drawing title:
LEGENDS, SCHEDULES, EQUIPMENT LISTS, & NOTES

LMC SCIENCE 313-023-112.01-0-00.00
drawing no:
P0.1
drawing of ?

SCIENCE BUILDING
LOS MEDANOS COLLEGE
Pittsburg, CA
Contra Costa Community College District

OVERFLOW RAINWATER LEADER DOWNSPOUT DETAIL

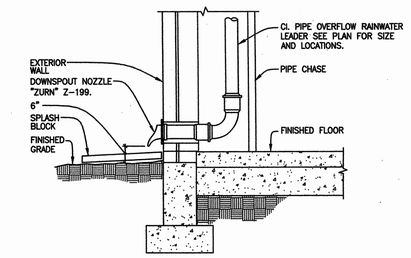
Per response to RFI 237, piping for overflow nozzles at the telescope storage room are to run down the east wall, which is a type 1 wall. This wall type does not allow enough physical room within the wall cavity to install the overflow nozzle per 12/P5.1. Possible solutions are to change the wall type or to route the piping inside the room (visible to those in the room) and turn horizontal at bottom of wall for the downspout nozzle. Please advise.

Request: Date Required: 6/13/2006
Per response #237: Overflow Nozzles shown at Telescope Storage, type 1 wall does not allow enough space for Detail 12/P5.1.
Please advise
